**Section 12A Application No.Y/I-DB/2  
For rezoning the permissible use from staff quarters to flats at Area 6f, Discovery Bay  
Response to Comments**

**Section 12A Application No. A/I-DB/2**  
**To Amend Discovery Bay Out Zoning Plan**  
**For rezoning the permissible use from staff quarters to flats**  
**At Area 6f, Discovery Bay**

**Response to Comments**

Section 12A Application No.A/I-DB/2 for rezoning the permissible use from staff quarters to flats at Area 6f  
 Applicant's response to the departmental comments made available by District Planning Office on 7, 12, 13, 14, 20 and 25 April 2016

**TITLE: BASELINE VISUAL ENVELOPE (ZVI), VSRs & VIEWPOINTS**

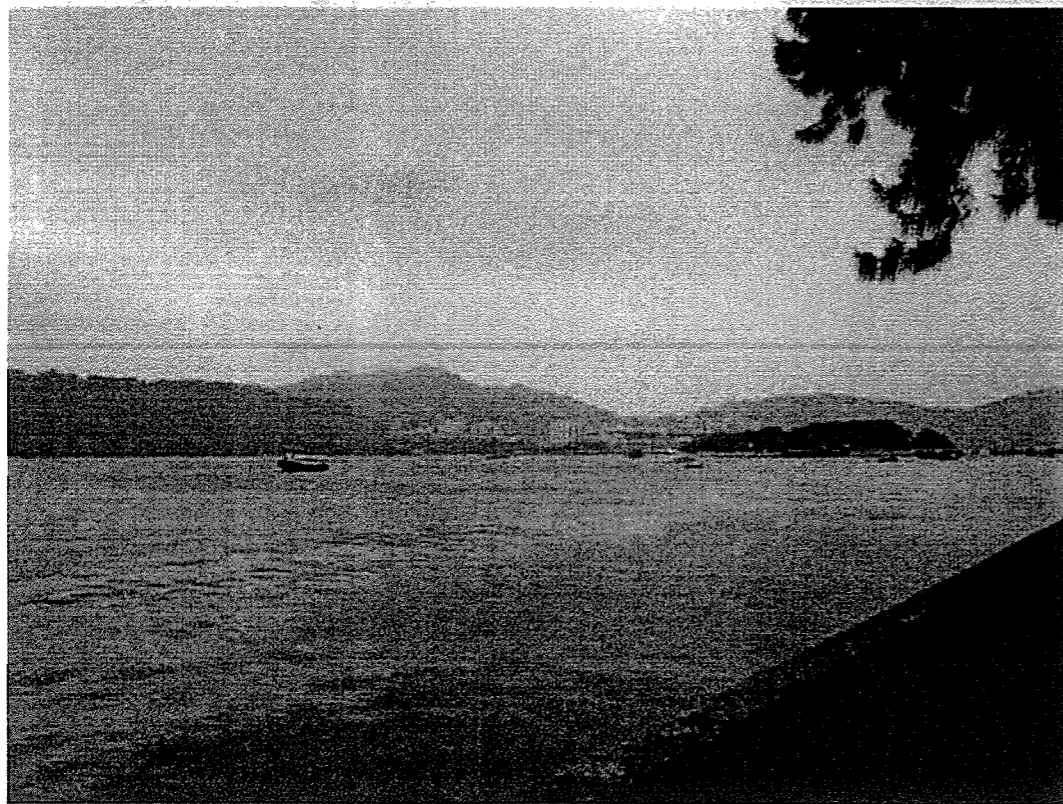
<p>CTP/UD&amp;L, PlanD's comment</p>	<p><b>Applicant's response</b></p>
<p>In order to help presenting the case to the Town Planning Board, photomontages as viewed from Tai Pak Wan Beach and Peng Chau should also be included in the visual appraisal.</p>	<p>Photomontages as viewed from Peng Chau and Tai Pak Wan Beach are provided in Annex B and discussed below.</p> <p><u>VSR REC11 (VP13): Pedestrians on Peng Chau Island Promenade</u>  This VSR Group has existing views north-west across the open expanse of sea towards the site. The existing buildings on the peninsula all lie beneath the ridgeline of the mountains beyond and do not form dominant visual elements. Following construction, the residential buildings will be visible. However, they will be perceived as having a similar height to the existing residential buildings in the foreground such as Peninsula Village and La Serene. The magnitude of visual change is assessed as <i>Small</i> due to the distance of view, partial visibility and degree of compatibility of the new forms with the existing building mass. The sensitivity of this VSR Group is <i>Medium</i> as it is a working waterfront as well as a public promenade. The resulting visual impact significance is assessed as <i>Slight</i>.</p> <p><u>VSR REC12 (VP14): Users at Tai Pak Wan Public Beach</u>  Residents and Visitors using Tai Pak Wan Public Beach currently have distant views of the existing Midvale Village and Parkvale Village. Following construction, the new 18 residential buildings will be visible between the two existing developments. The magnitude of change is assessed as <i>Small</i> as existing views are open and panoramic and the Proposed Development will only constitute a minor change to the overall visual context and the new residential buildings are addition to an existing building group. The sensitivity of this VSR group is assessed as <i>High</i> as although it is assumed that their main focus of attention is the beach, the surrounding views are a contributing factor to the amenity of the beach setting. The resulting visual impact significance would be <i>Slight</i>.</p> <p>A photomontage from D Deck which is in close proximity to Tai Pak Wan illustrating views experienced by pedestrians has also been prepared and provided in the Annex B, and discussed below.</p> <p><u>VSR REC10 (VP12): Pedestrians at D Deck</u>  Pedestrians at D Deck currently have views of the hills to the west and Parkvale Village in the foreground. Following construction, portions of the two new residential buildings will be visible behind Crystal and Coral Court. The sensitivity of this VSR group is assessed as <i>Medium</i> as although it is assumed that their main focus of attention to the waterfront and plaza, the surrounding views of the hills are a contributing factor to the ambience of the location. Views of the new residential buildings will be of short duration and from some distance and partly obstructed by existing buildings and the magnitude of perceived visual change is assessed as <i>Small</i>.</p>

TITLE: **PHOTOMONTAGE - VP15 (VSR T3) FROM MIDDLE LANE**

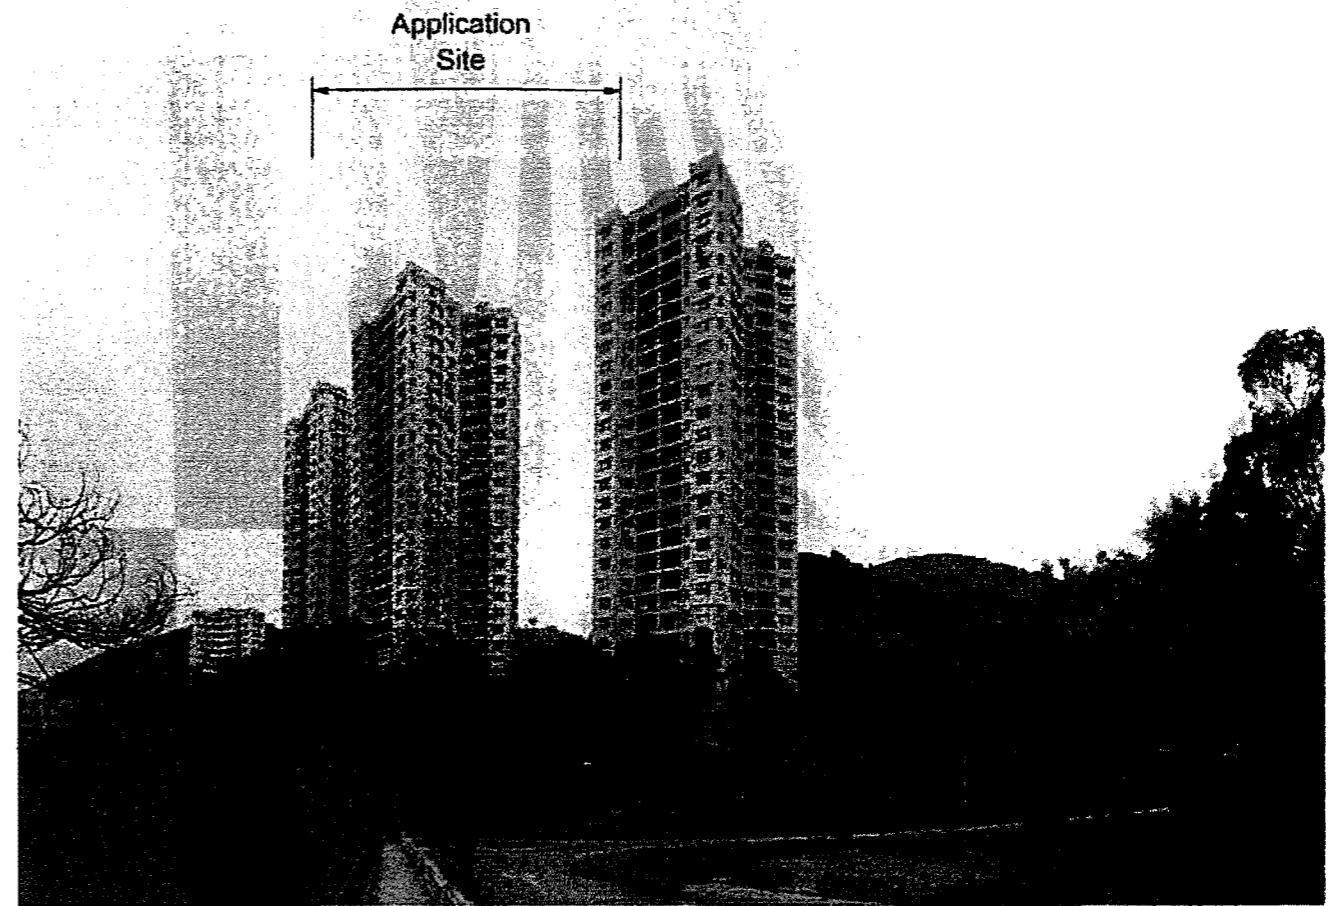
<p>CA/CMD2, ArchSD</p>	<p><b>Applicant's response</b></p>
<p>(i) The applicant should provide more viewpoints from north direction, such as from Midvale Village, for reviewing the visual impact.</p>	<p>Please see Annex B for the photomontage view from Middle Lane, and discussed below.</p>
